Reference: **STONEYBROOK NORTH**
ADD2013-00083

This letter is provided in response to the review comments dated September 3, 2014. With this letter we are submitting revised plans and additional information requested for the project. Presented below are responses to each review comment.

MASTER CONCEPT PLAN	CHECKED	SCALE	SHEET
STONEBROOK NORTH	EMH	1"=300'	1
LEE COUNTY, FLORIDA	DRAWN		
	DESIGN		
	DRAWING		
	PROJECT		
DATE	5/6/2014	1447

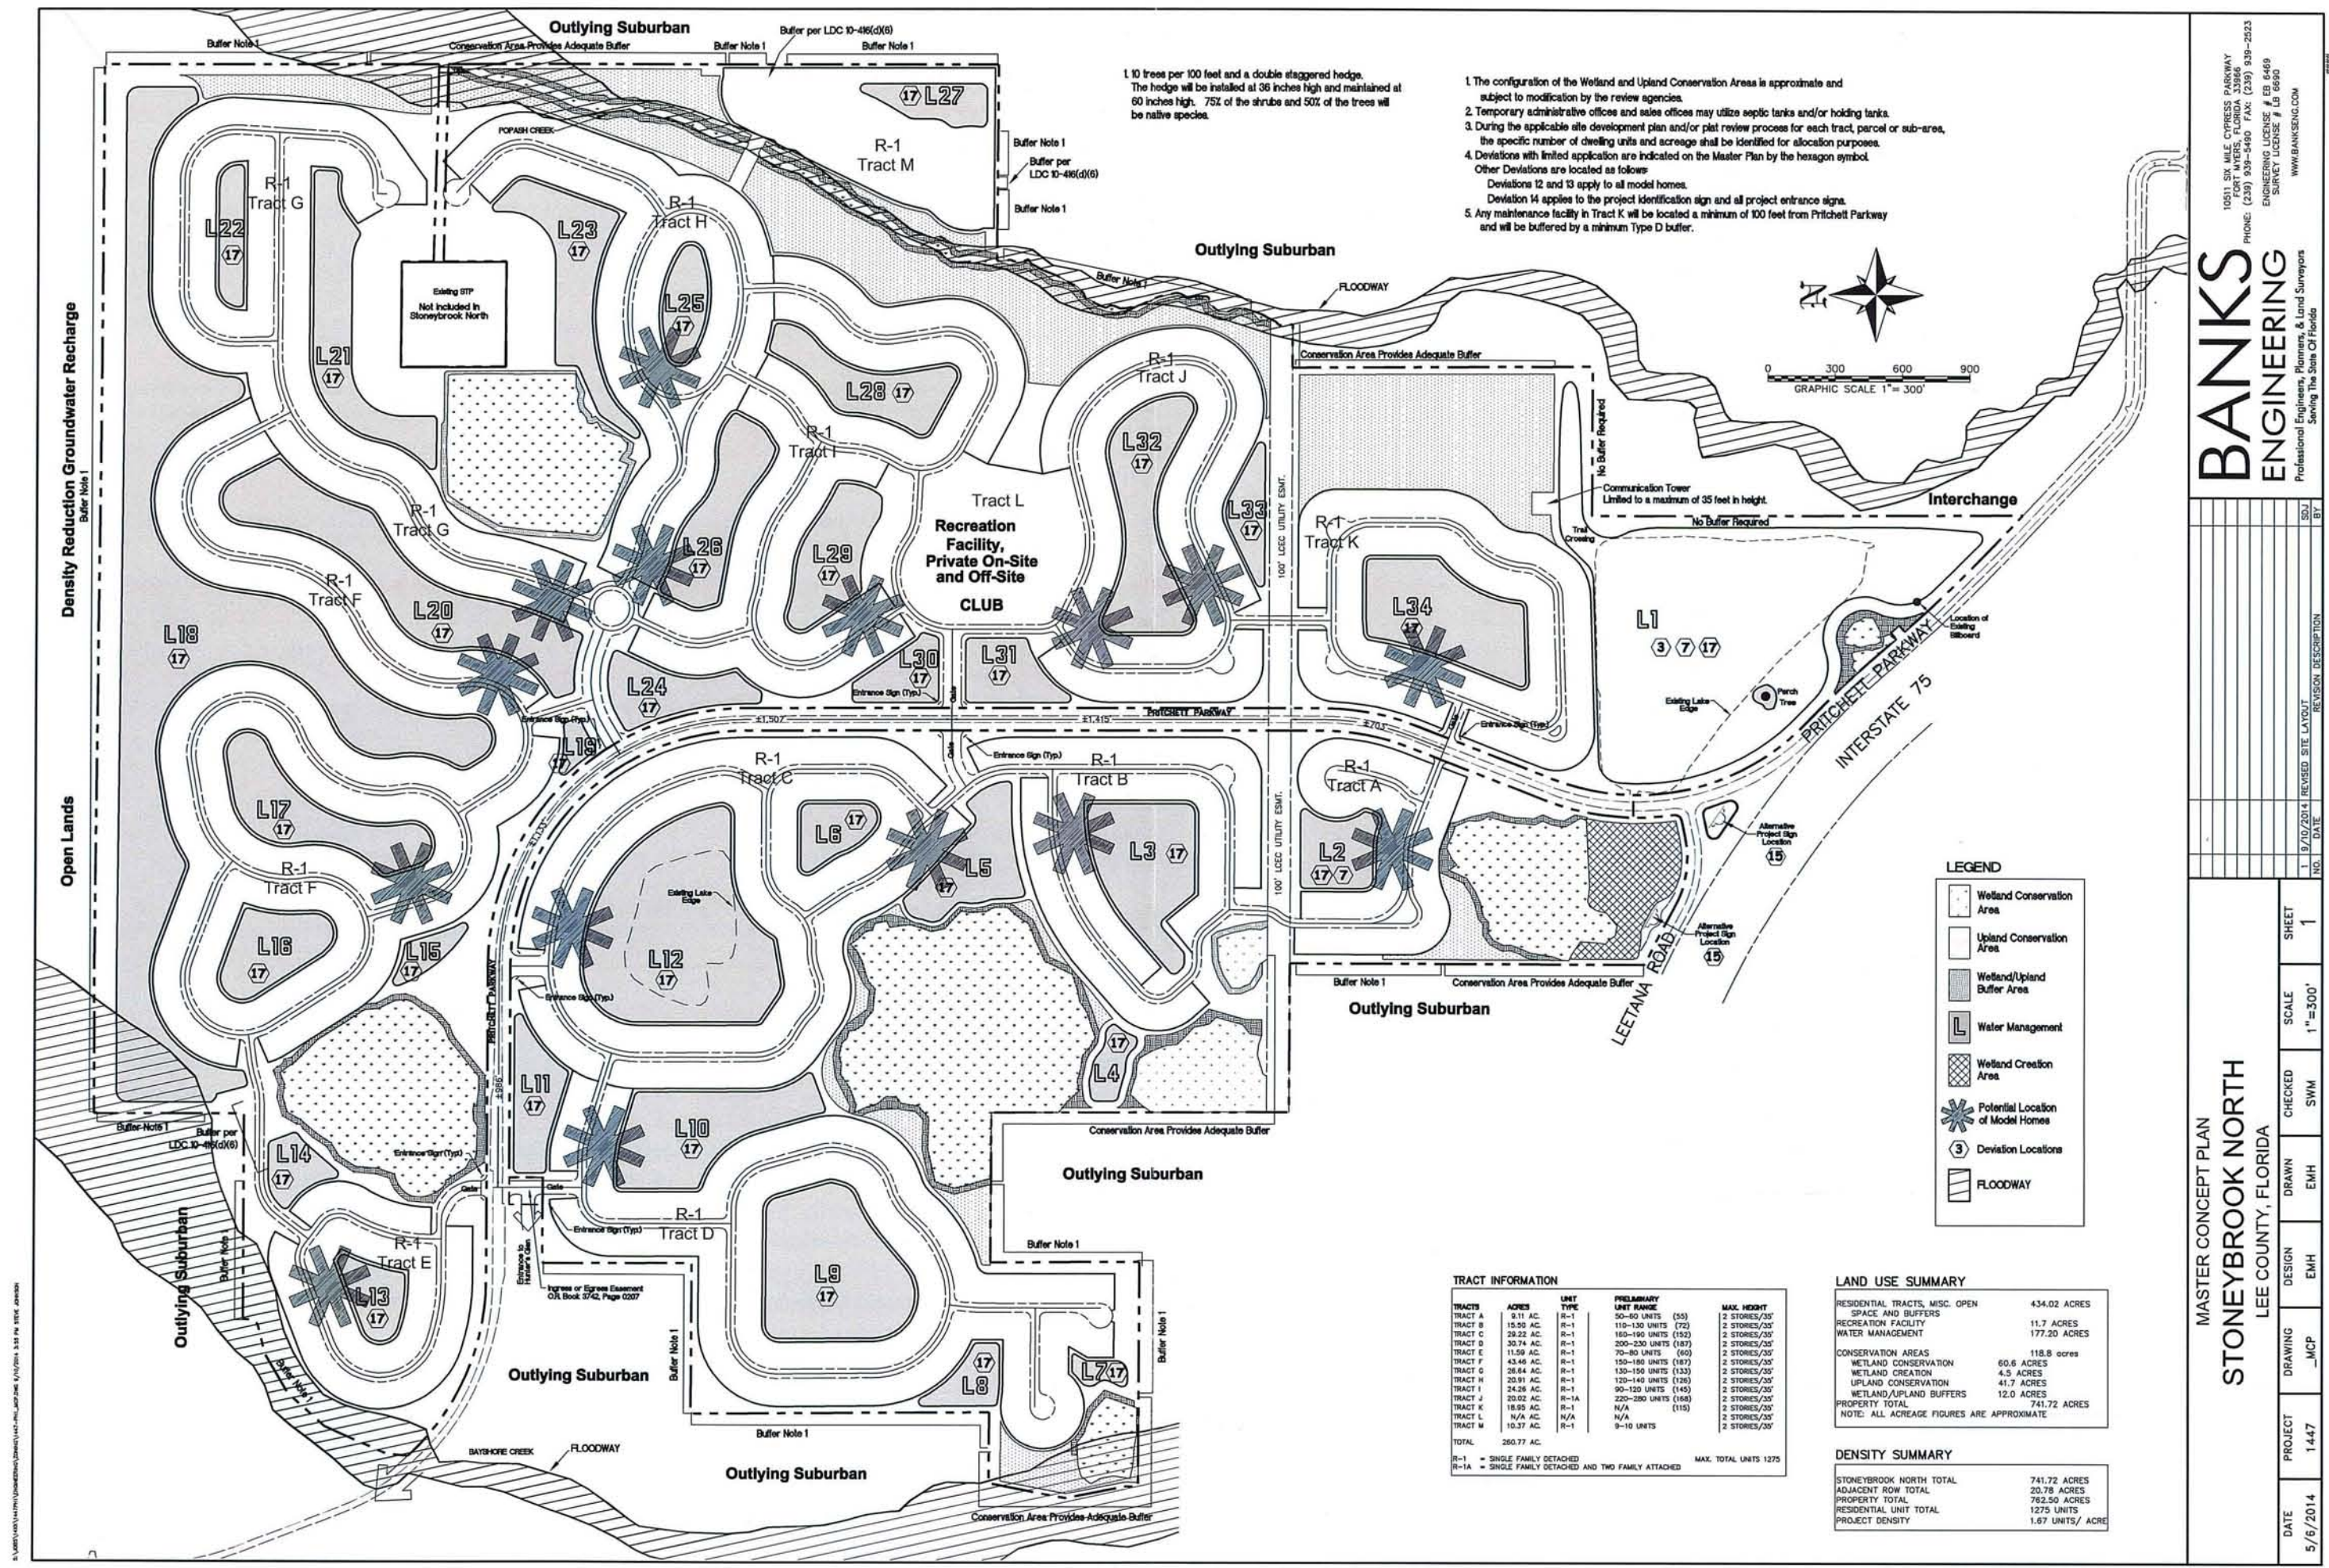
Comment 2: Please revised the MCP to label Tract L (note the recreation lot should have its own tract number).

Response: *The MCP has been revised and Tract L has been labeled.*

EXHIBIT "E"

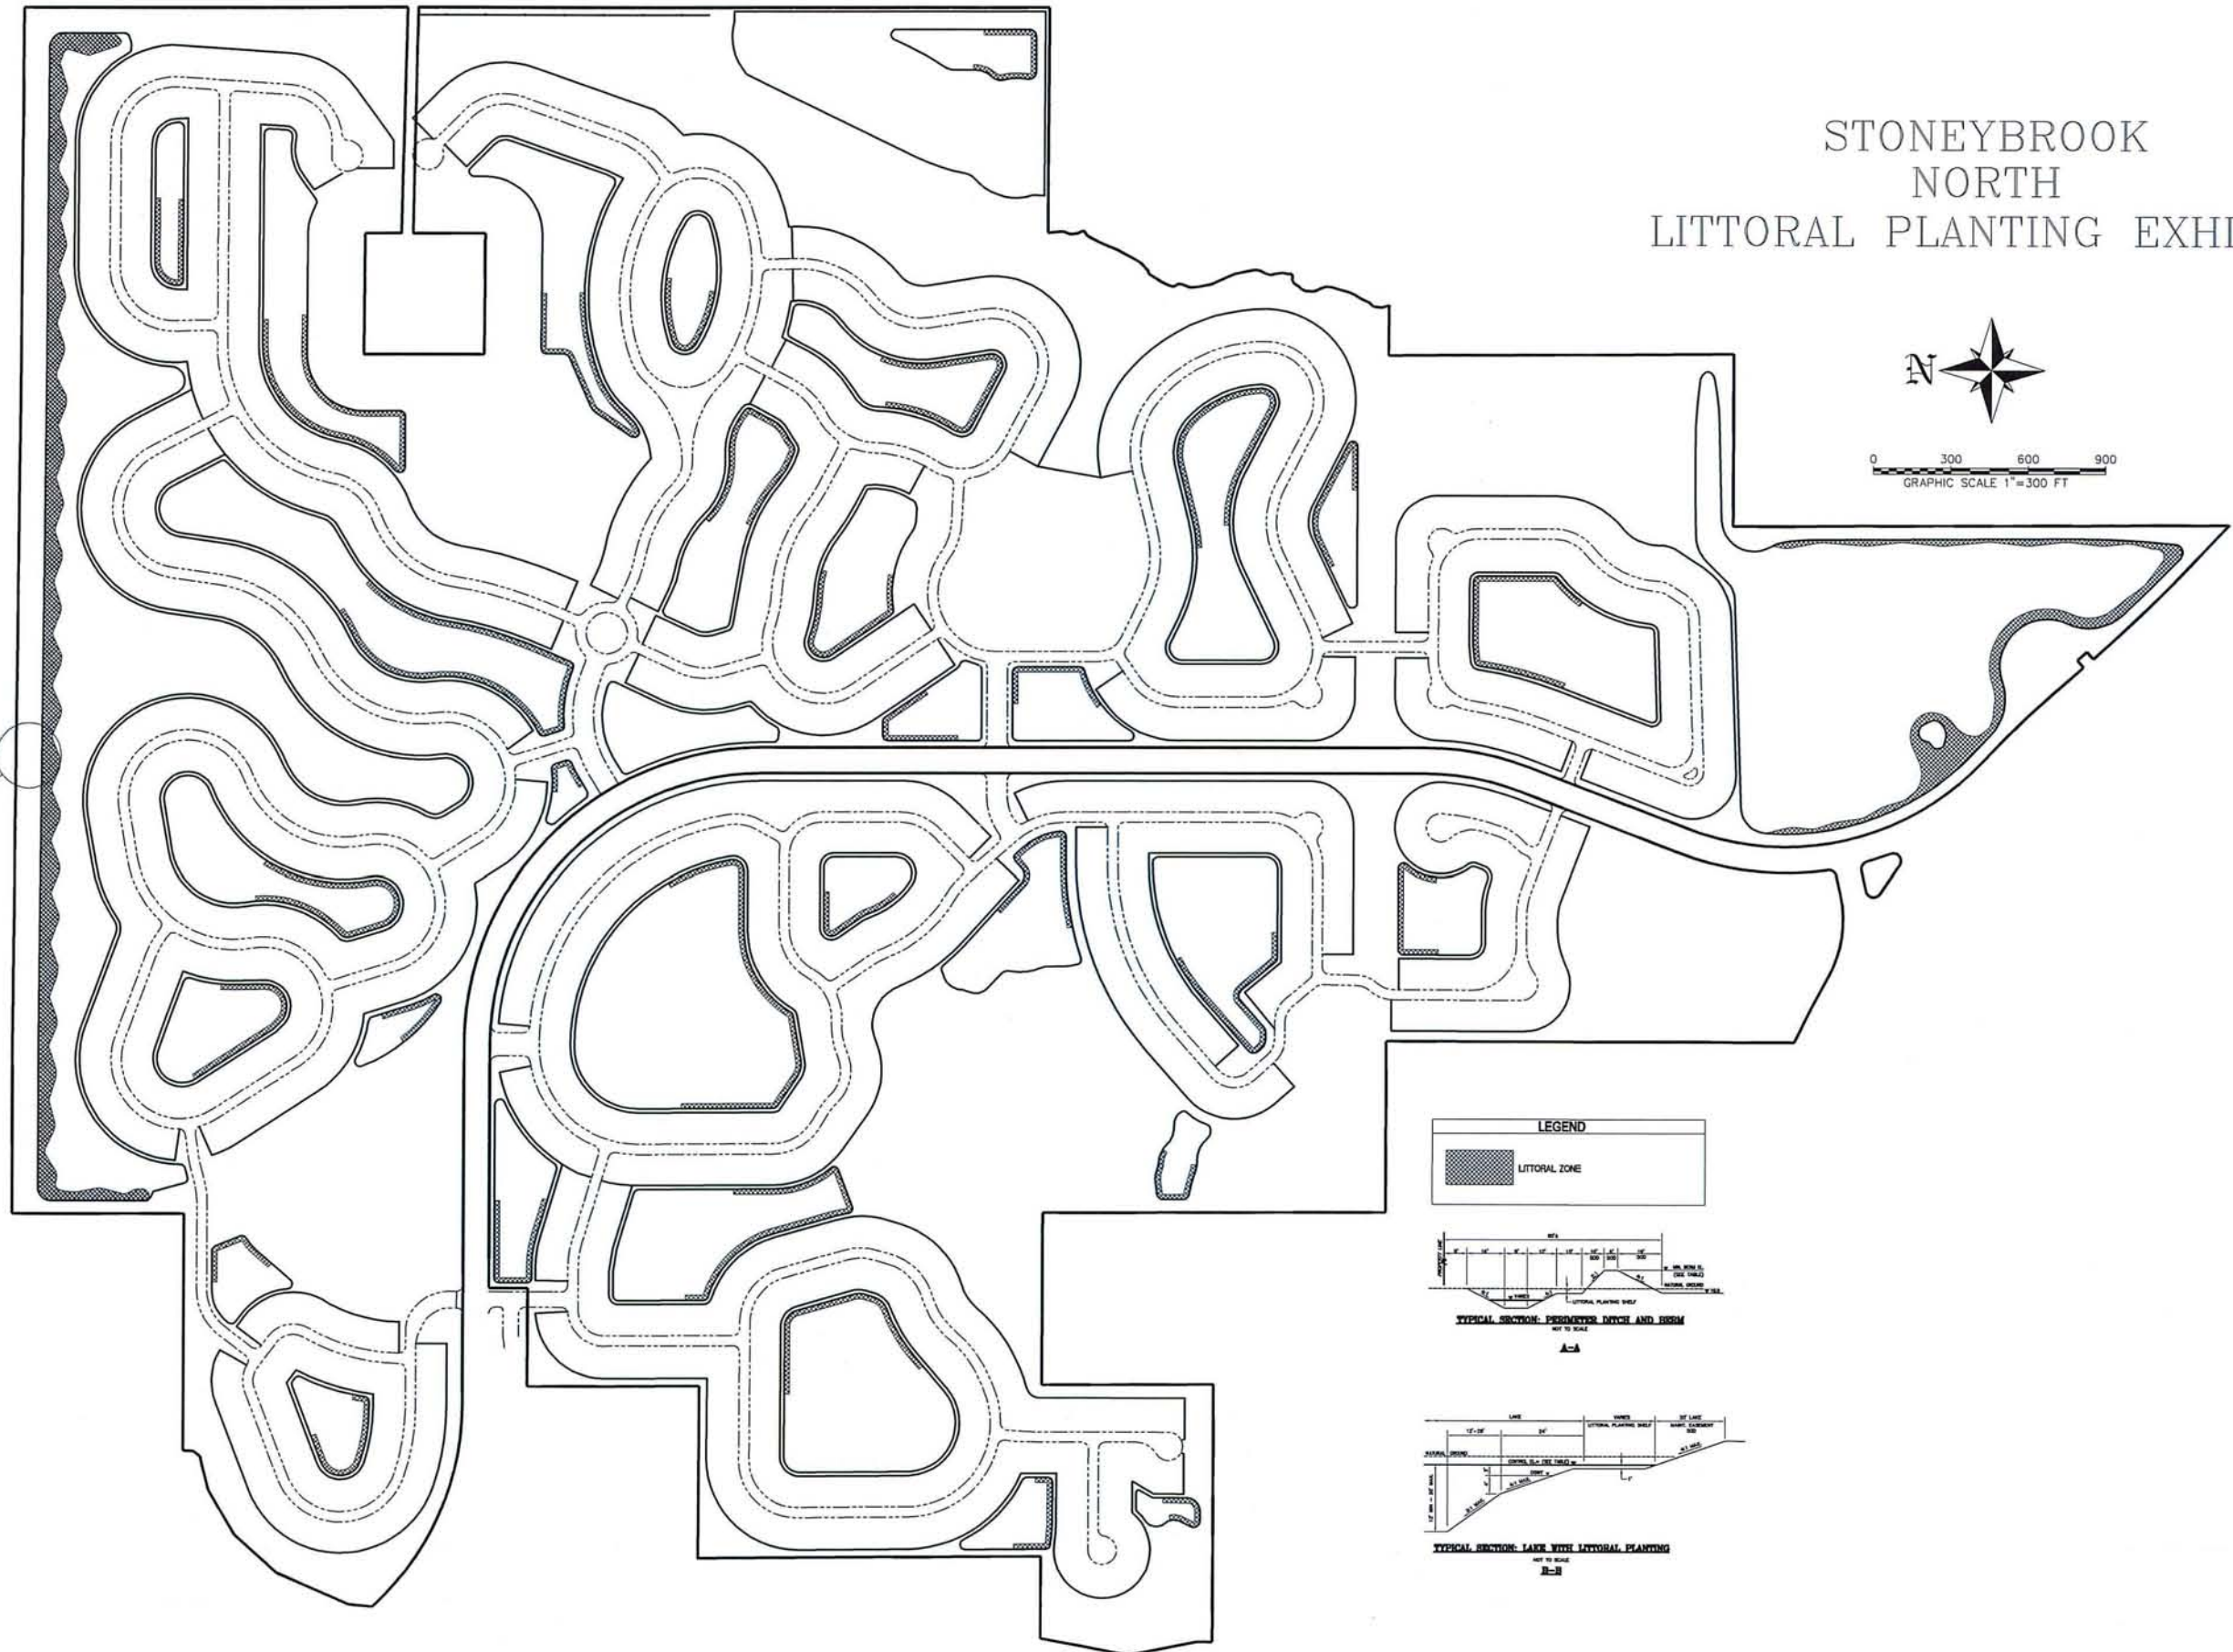
Comment 1: Please provide revised exhibits E and F which demonstrate the updated layout and lake numbering.

Response: *Exhibits E and F have been revised to match the new layout and lake numbering.*
